# LSD Attwood Cafeteria and Kitchen Renovations

## Addendum No. 1

<b>Project Name:</b>	Attwood Cafeteria and Kitchen Renovations SO-1851	<b>Date:</b>	April 3, 2026
<b>Project Location:</b>	915 Attwood Dr, Lansing, MI 48911	<b>Architect's Project #:</b>	26000747A
<b>Owner/Client:</b>	Lansing School District	<b>Attention:</b>	David Beckering
<b>Issued to:</b>	Beckering Construction	<b>Email:</b>	djb@beckering.com
<b>City/State:</b>	Grand Rapids, MI	<b>Zip:</b>	49548

**2 INT NORTH ELEV**  
SCALE : 1/4" = 1'-0"

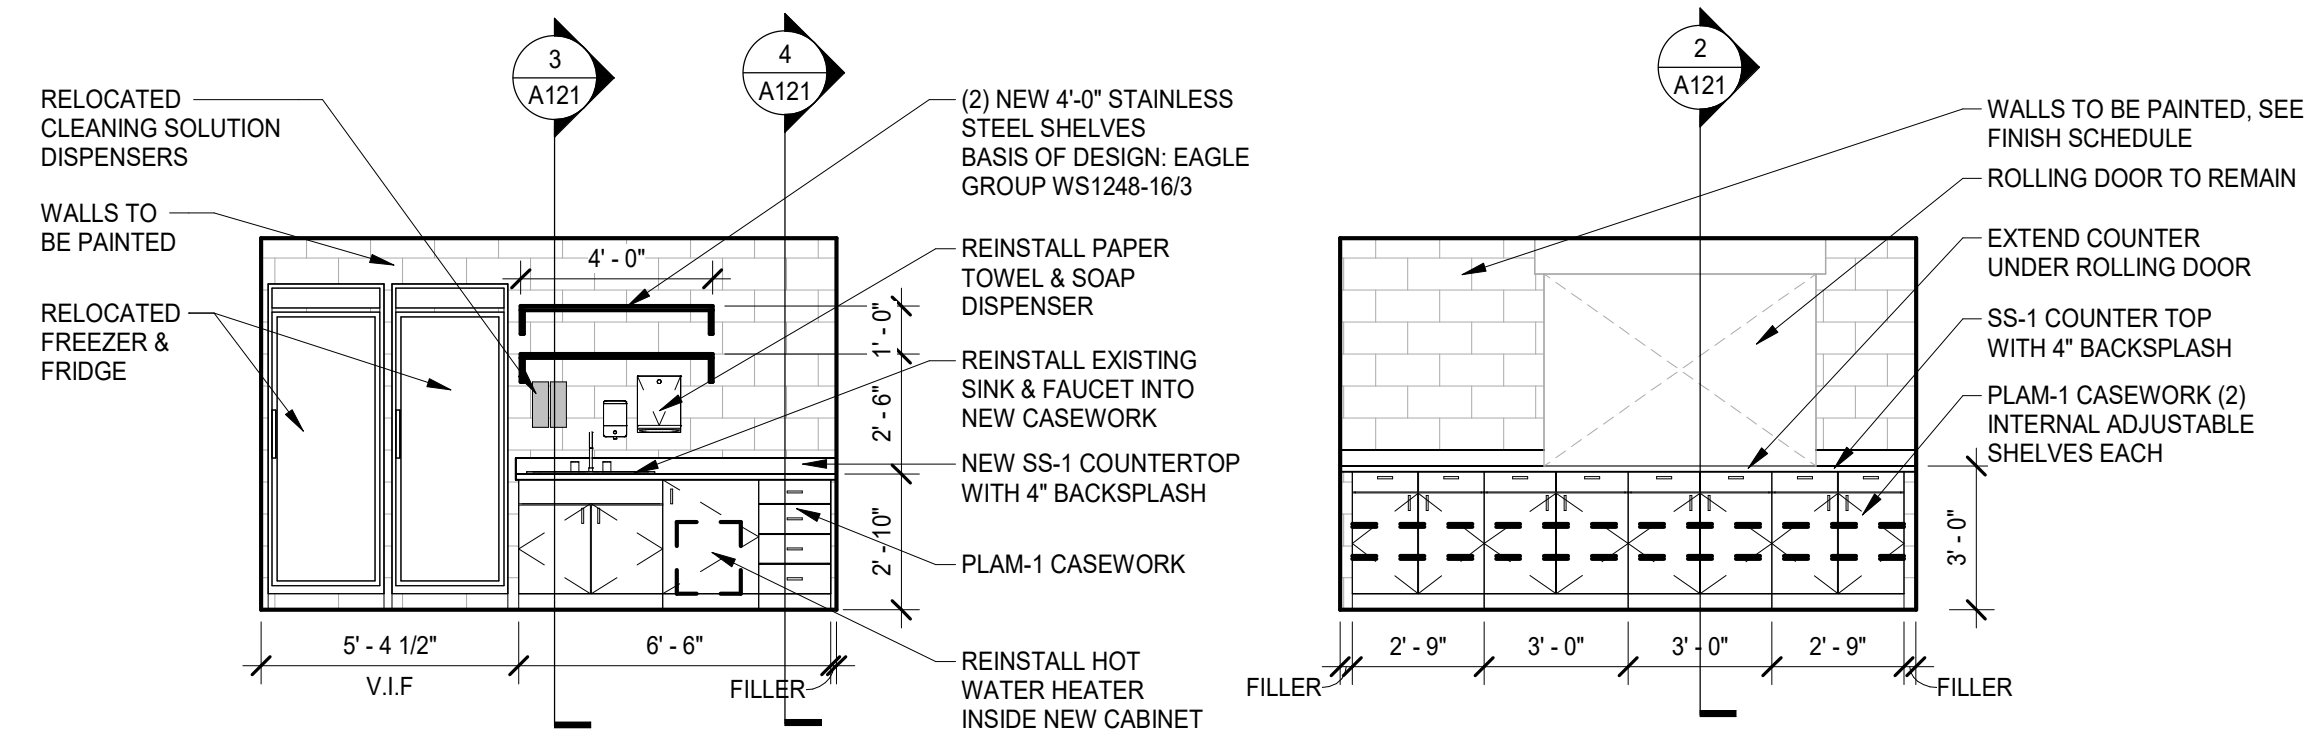
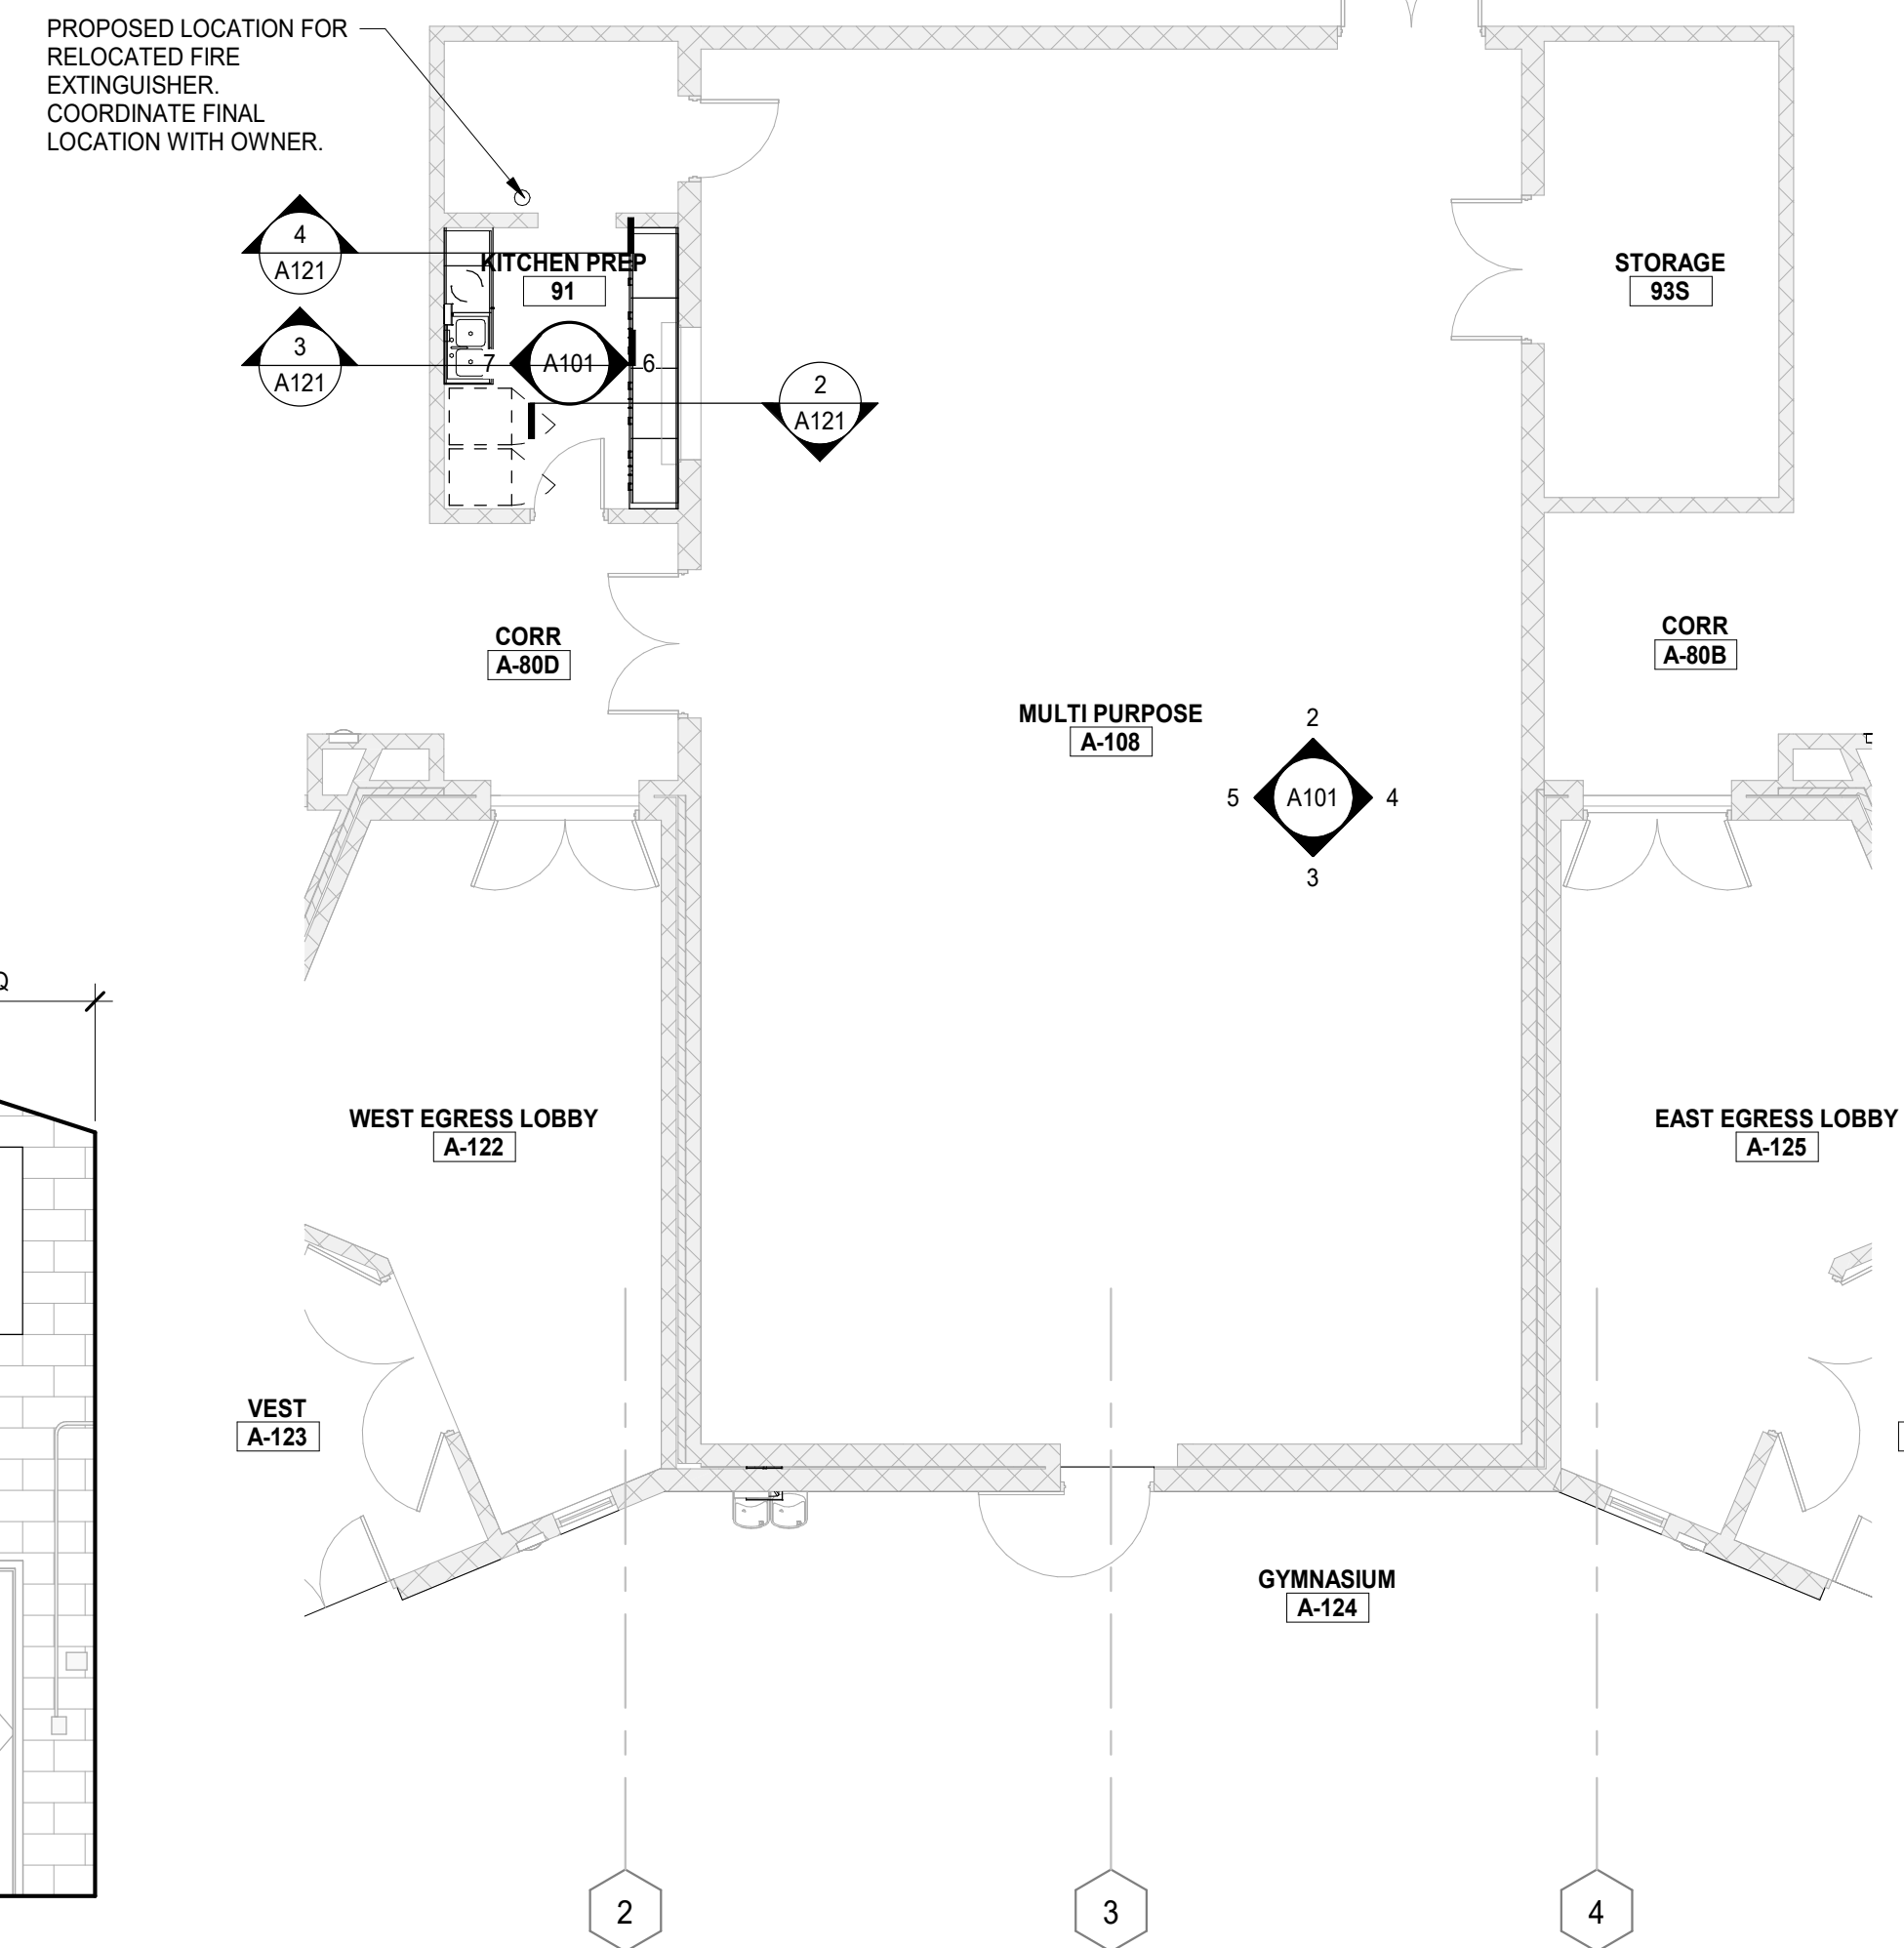
- G000 – COVER Sheet (Reissued)
  - Added electrical sheets to sheet list
- A101 – FIRST FLOOR PLAN AND ELEVATIONS (Reissued)
  - Added paint designation on tectum panels in elevation
- A141 – FIRST FLOOR FINISH PLAN (Reissued)
  - Revised painting specification to include paint system for tectum panels.
  - Revised steel decking paint specification to indicate flat finish.
  - Updated paint basis of design.
  - Revised color of tectum panels.
- E100 – ELECTRICAL SYMBOLS AND SPECIFICATOINS
  - New sheet
- EL101 – FIRST FLOOR PLAN – LIGHTING
  - New sheet
- EL102 – FIRST FLOOR PLAN – EMERGENCY LIGHTING
  - New sheet
- EP101 – FIRST FLOOR PLAN – POWER
  - New sheet
